**NRC ADVANCED MANUFACTURING PROGRAM (AMP)
WINNIPEG, MB**

<u>Contents</u>	<u>No. of Pages</u>
Addendum No. 2	57
<u>Attachments:</u>	
Specification Section 05 50 00 Metal Fabrications R1	7
Specification Section 08 41 14 Aluminum Framed Entrances and Storefronts	4
Specification Section 08 50 00 Explosion Venting Wall System	3
Specification Section 33 46 16 Sub-drainage Piping	3
A202 RCP – LEVEL 1 - WEST (Rev. 2)	1
A203 RCP – LEVEL 1 – EAST (Rev. 2)	1
A204 RCP – LEVEL 2 - WEST (Rev. 2)	1
A205 RCP – LEVEL 2 – EAST (Rev. 2)	1
DA-087 – PARTIAL 12/A821 – LEVEL 1 WEST – ACW1 LOBBY	1
DA-088 – PARTIAL 9/A821 – LEVEL 2 WEST – WEST ACW1 CORRIDOR	1
DA-089 – PARTIAL A200 – RCP – LEVEL 0 – WEST	1
DA-090 – PARTIAL A201 – RCP – LEVEL 0 – EAST	1
DA-091 – REVISION TO A1000 DOOR SCHEDULE TYPES DETAILS	1
DA-092 – A111 PLAN – ROOF - EAST	1
DA-093 – REVISION TO A1000 DOOR SCHEDULE TYPES DETAILS	1
DA-094 – 9/A820 – CEILING DETAILS	1
DA-095 – A111 – PLAN – ROOF - EAST	1
DA-096 – A502 WALL SECTIONS	1

TYPICAL KINETIC SCREEN CONNECTION - ROOF (8/S303)

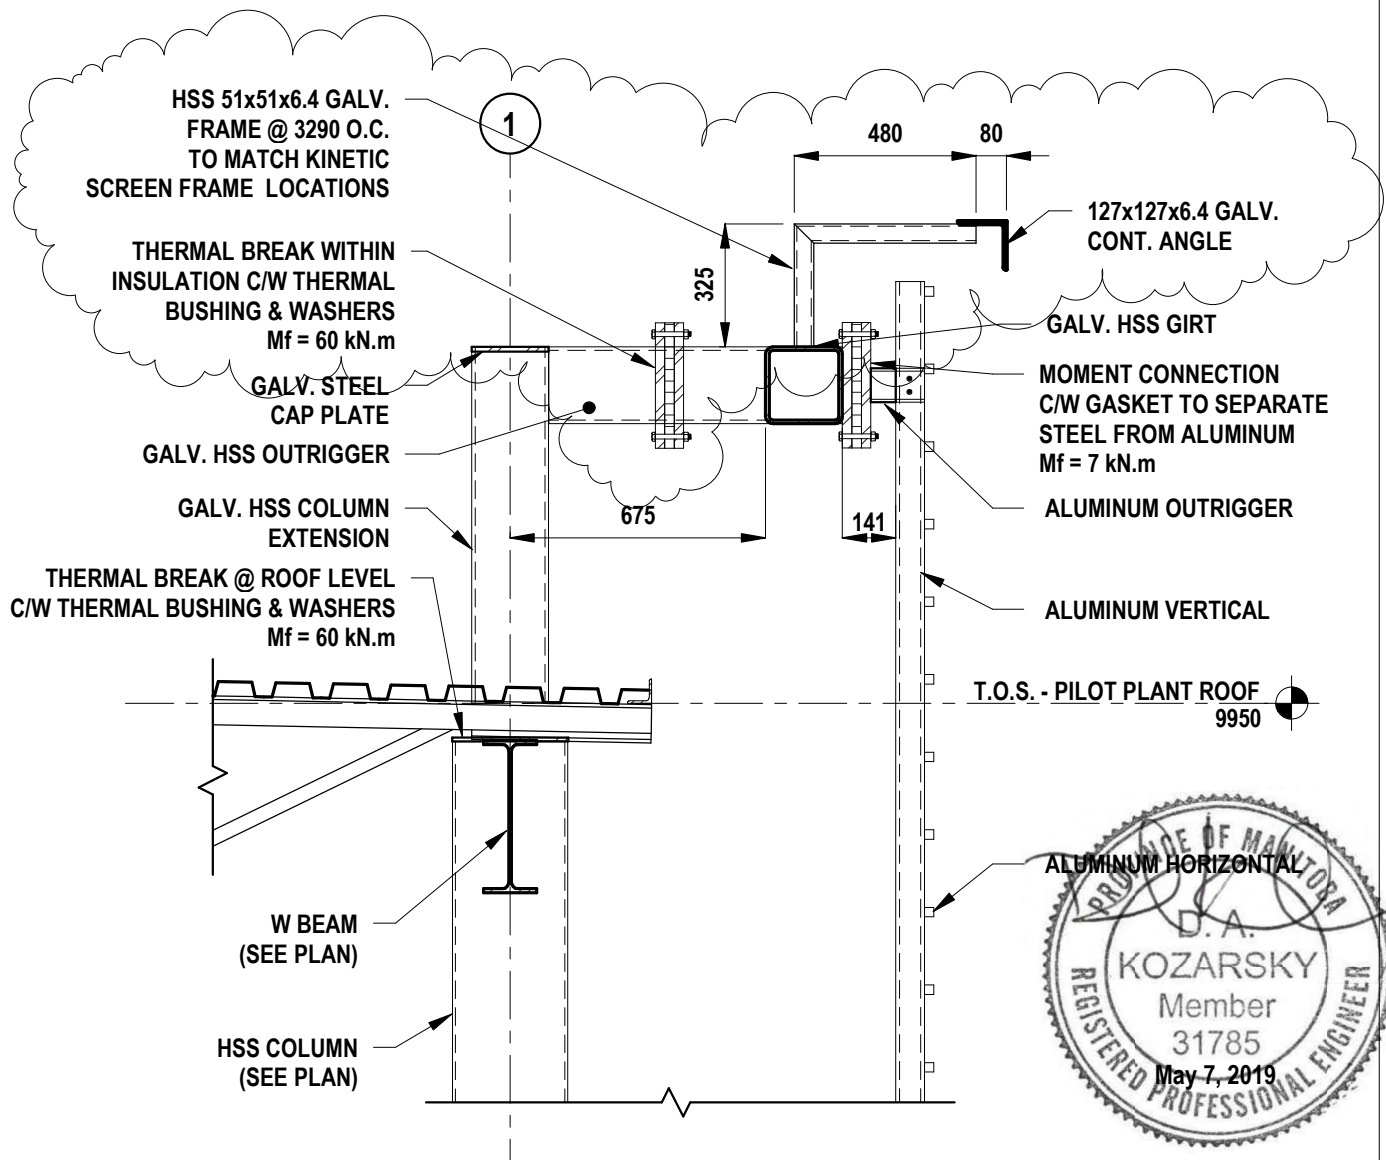
8	25-Apr-19	1. Ref. details 8/S303 and 9/S303 do not show the specific connection required between galv. HSS girt and aluminum, currently shown as “moment connection”. Please provide details for the specific connections to be made between HSS girts and aluminum as it relates to the installation of the kinetic screens.		Structural	Detailed connection design shall be by the structural steel supplier for the moments indicated.	Addendum #2 (item 6.4)
9	25-Apr-19	RFE 3	-	-	-	-
10	25-Apr-19	RFE 4	-	-	-	-
11	25-Apr-19	1) Can you please confirm if services (WWS, WS, Electrical) Will be in place on Red Fife Road prior to start of construction. Also, please confirm if this would include Fire Hydrants along Red Fife Road. 2) Can you please provide an approximate budget cost for this project		Civil/ Electrical/ Mechanical	1) WWS, WS, Hydrants on Red Fife Road have already been installed with service stubs in place for WWS and WS up to the NRC AMP property line (as shown on the Civil drawings C003 Rev.0). The exception to this is the 250 mm PVC C900 fire hydrant lead (including tee, gate valve) near the west parking lot that has not been installed yet. 2) PSPC will not be releasing the approximate budget cost for this project. To assist with bonding and insurance requirements, this project is estimated at a value over & above \$5,000,001.00.	- -

NRC ADVANCED MANUFACTURING PROGRAM (AMP) - WINNIPEG Red Fife Road, Winnipeg, Manitoba		REAL PROPERTY SERVICES Western Region	SERVICES IMMOBILIERS Région de l'Ouest
PARTIAL A200 - RCP - LEVEL 0 - WEST		R.076948.001	
		Drawing no.	No. du dessin
		DA-089

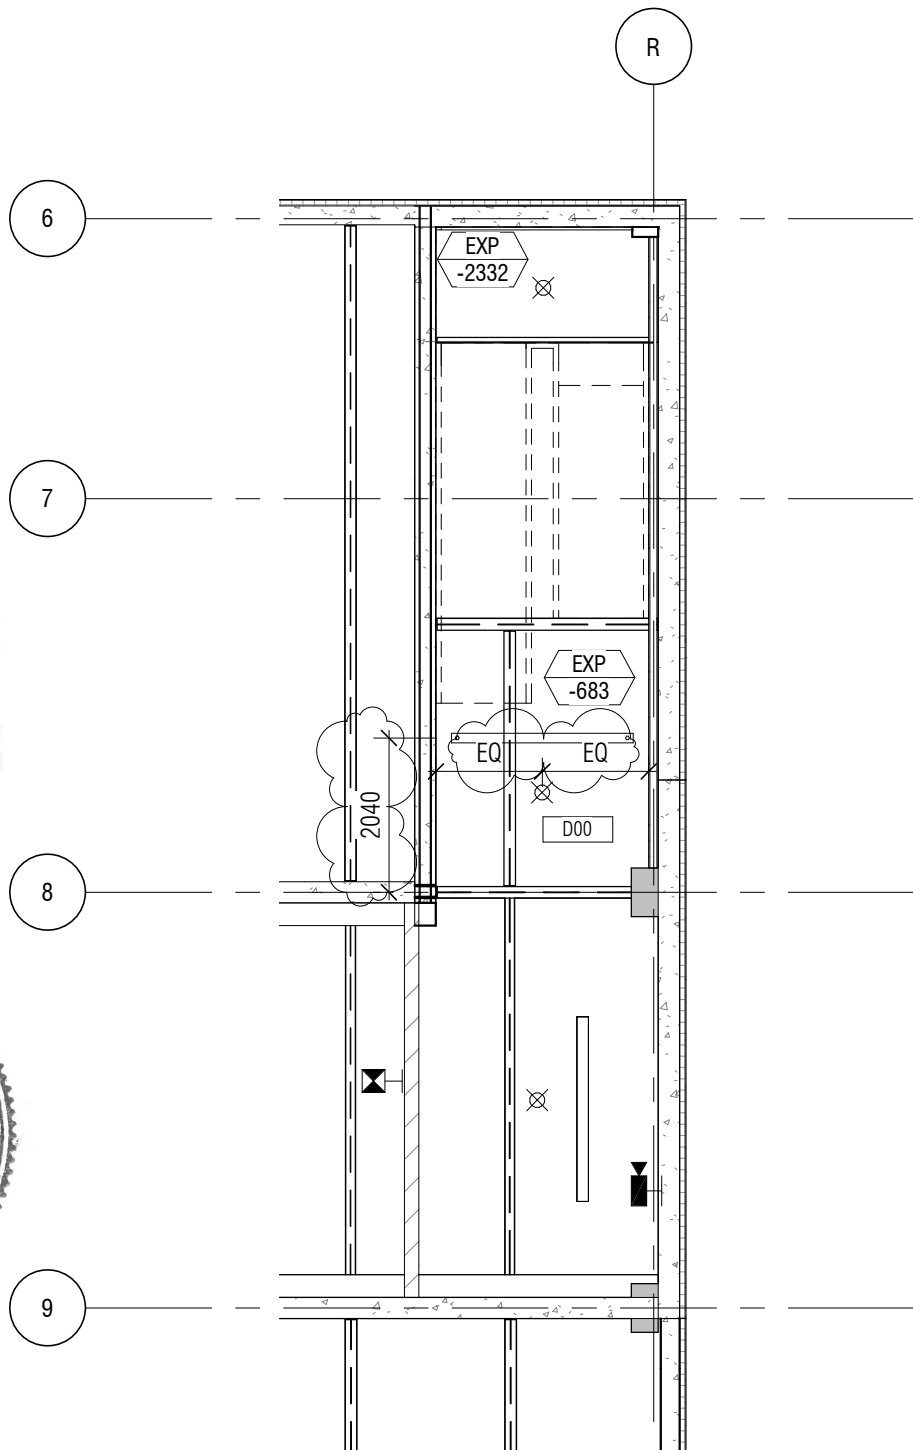
- 4.1 Refer to Drawing A200 RCP - Level 0 - West
.1 Drawing A200 is revised to indicate additional dimensions to clarify light fixtures location in stairs, and drawing is issued as part of this addendum. Refer to new DA-089 revision sketch attached to this addendum.

1
SECTION - KINETIC SCREEN @ EBW2 - DA-096

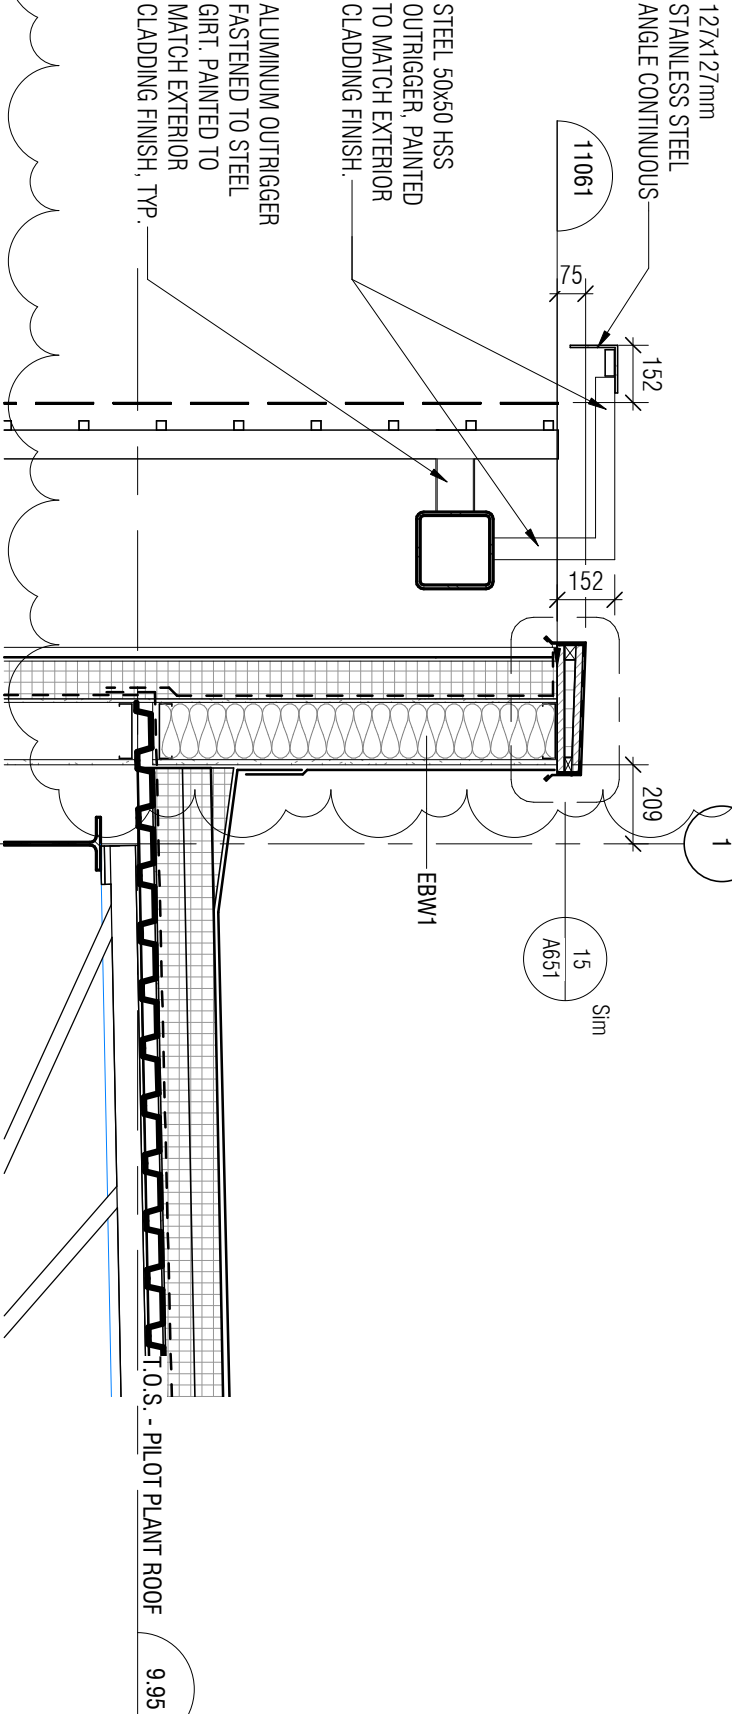
- 4.10 Refer to A502 – Wall Sections
 - .1 Revise detail 1 as indicated in the attached detail sheet, DA-096.
 - .2 Revise detail 2 as indicated in the attached detail sheet, DA-096.

2
SECTION - KINETIC SCREEN @ EBW1 & GLAZING - DA-096

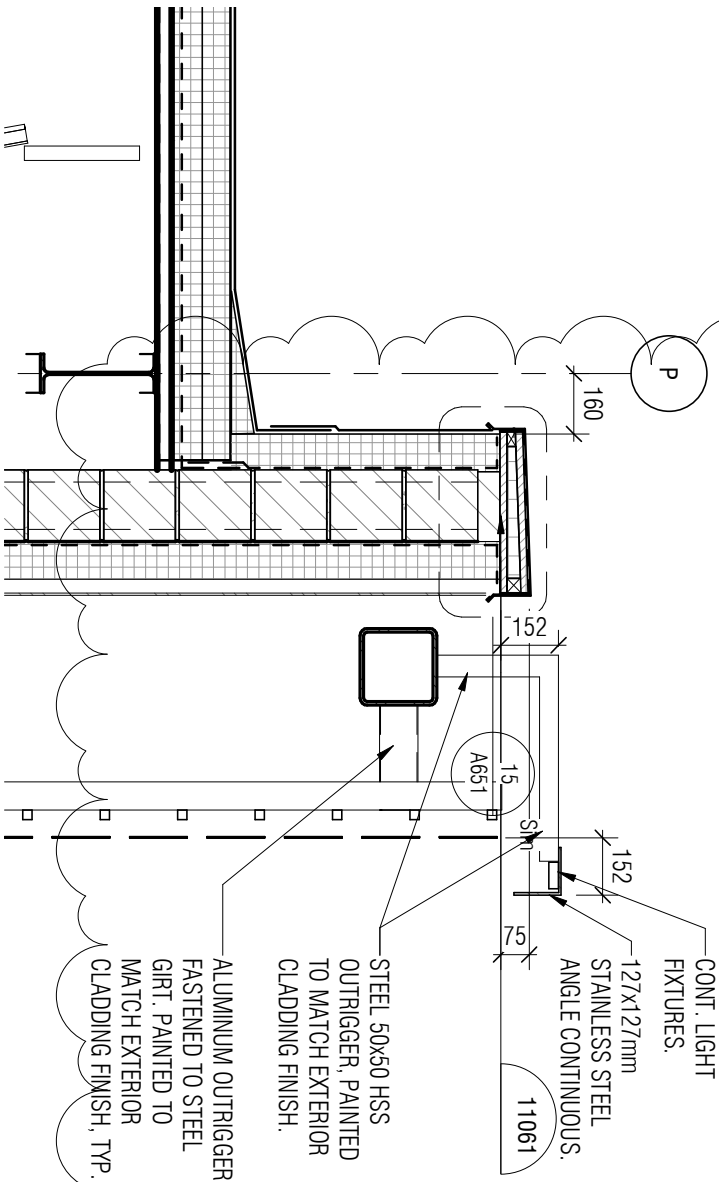
- .3 Revise detail 3 as indicated in the attached detail sheet, DA-096.
- 4.11 Refer to A652 – Section Details
 - .1 Add detail 14, Kinetic Screen @ EBW2 Parapet, as indicated in the attached detail sheet, DA-097.

LANDSCAPE SITE PLAN - OVERALL REVISION 1, FOR ADDENDUM #2

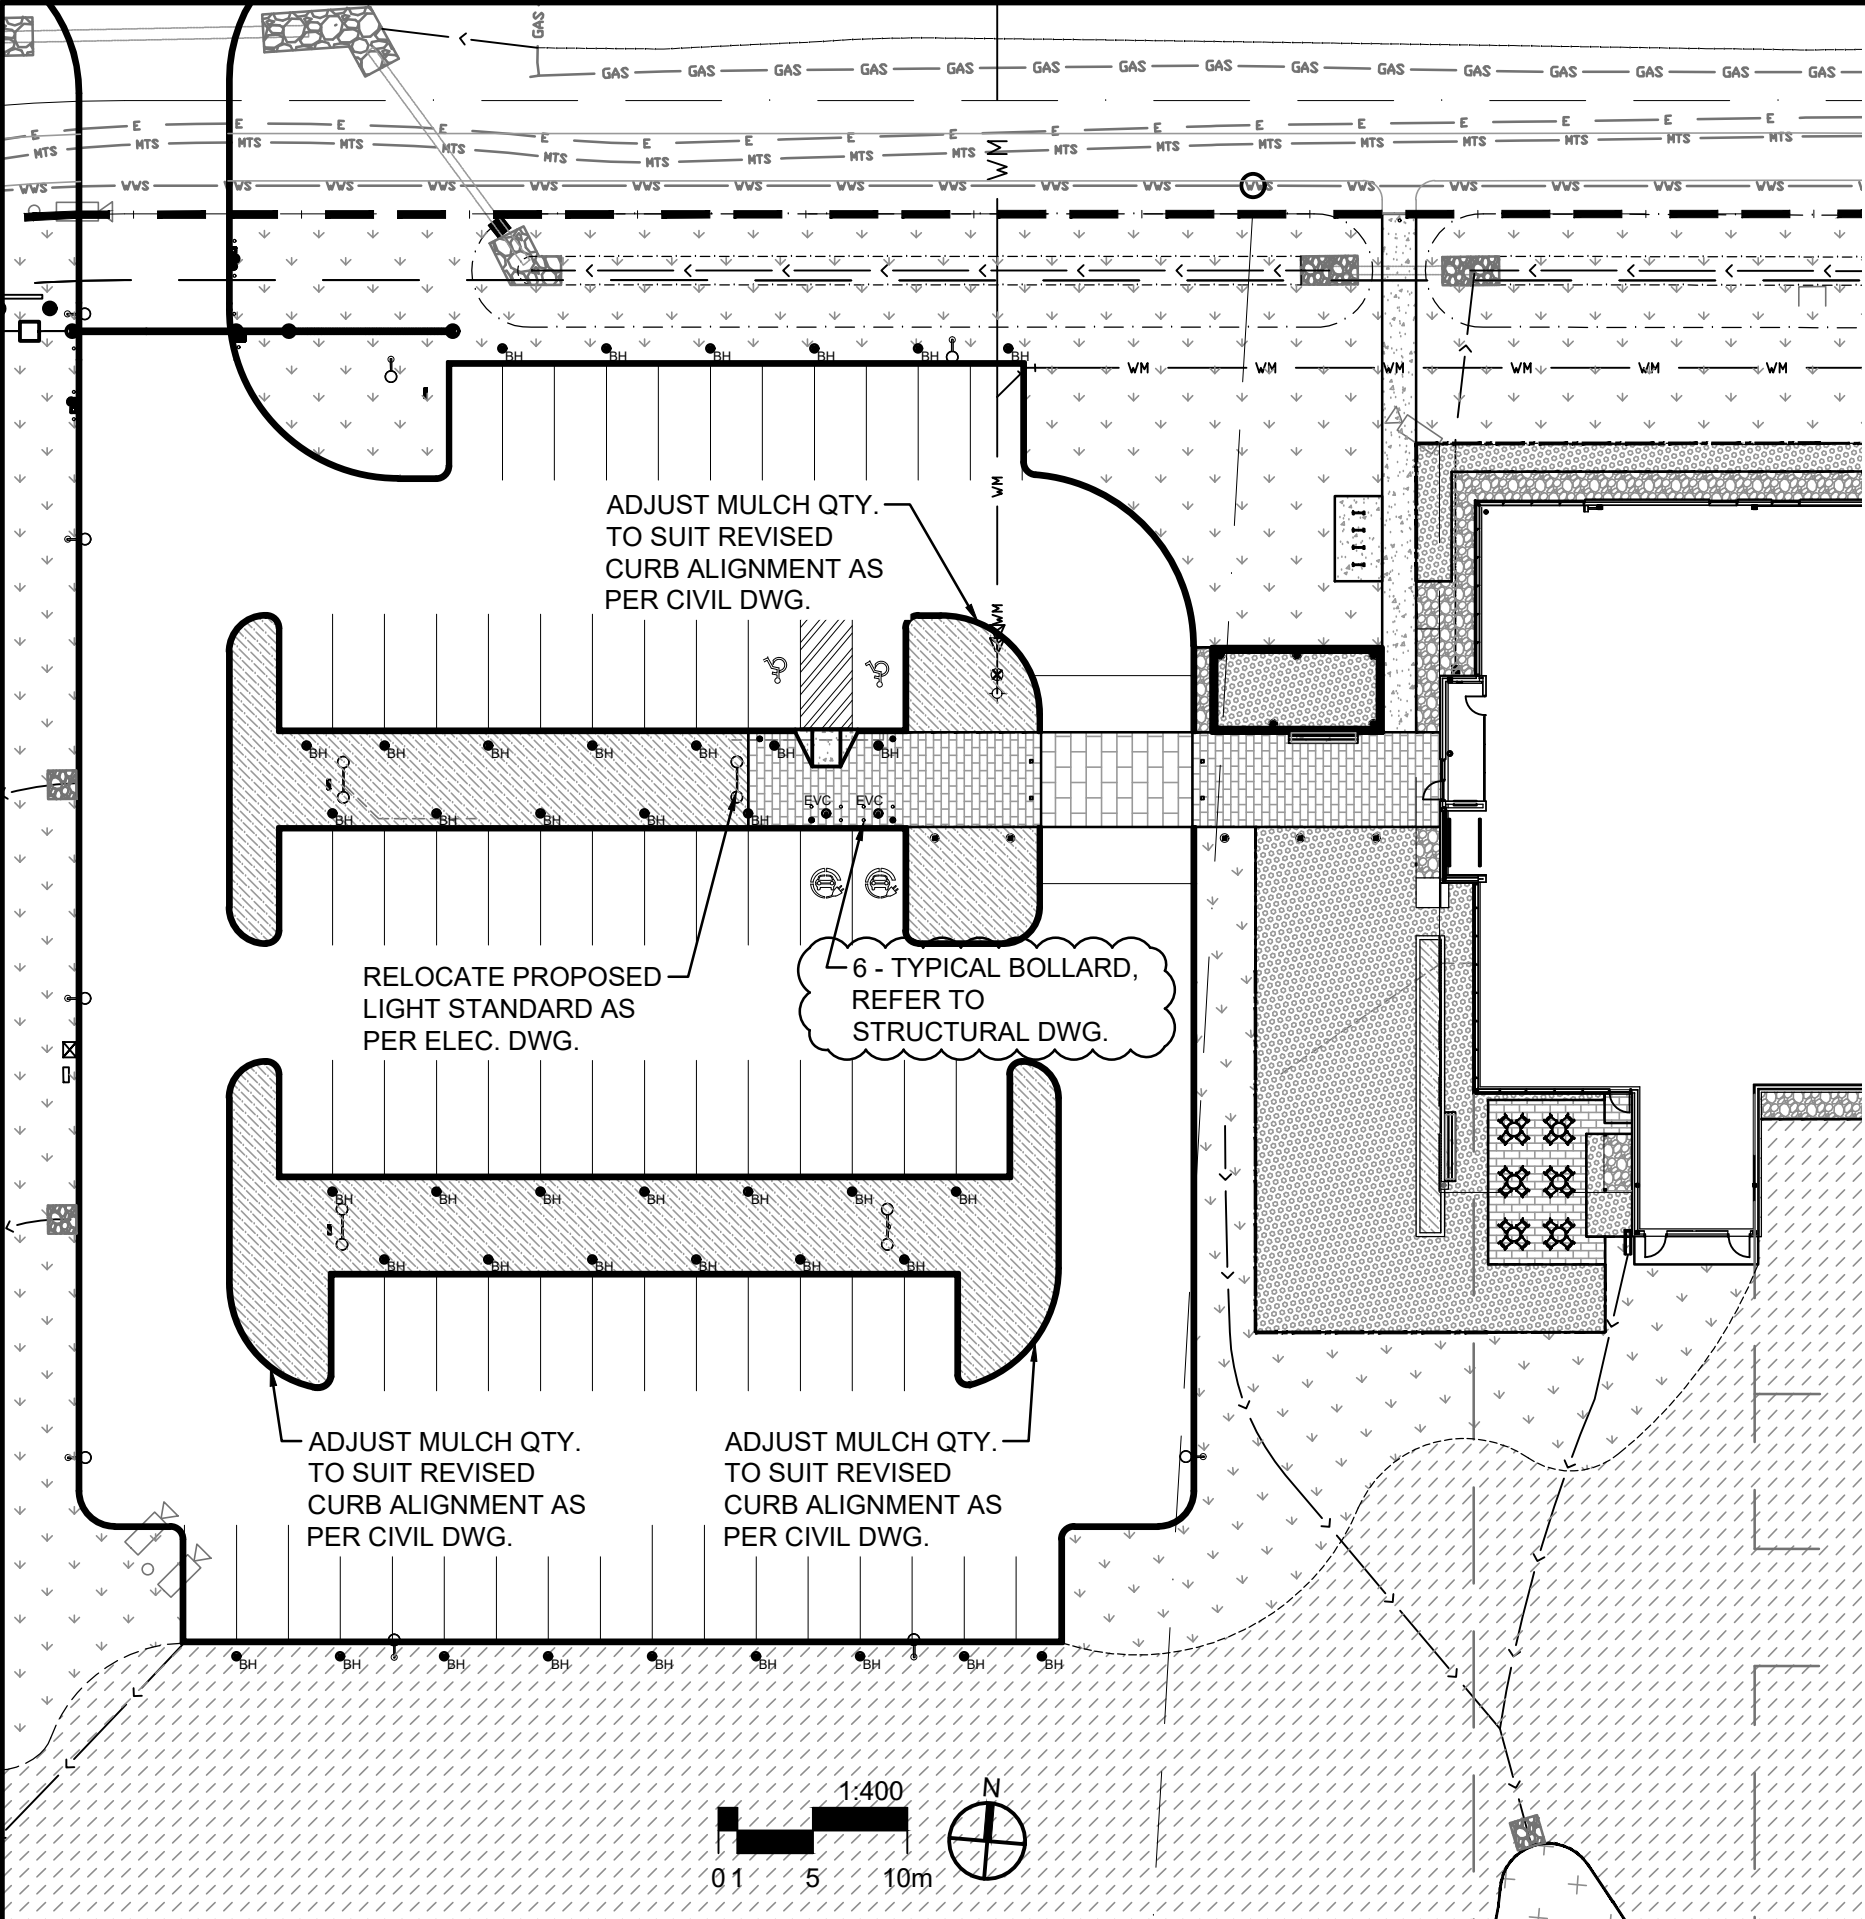
- 8.1 Refer to Drawing DL-01 revision sheet attached to this Addendum:
.1 Revise mulch quantity to suite revised curb alignment identified by Civil.
.2 Revise light fixture location identified by Electrical.
.3 Add 1 bollard near proposed Electrical Vehicle Charger.
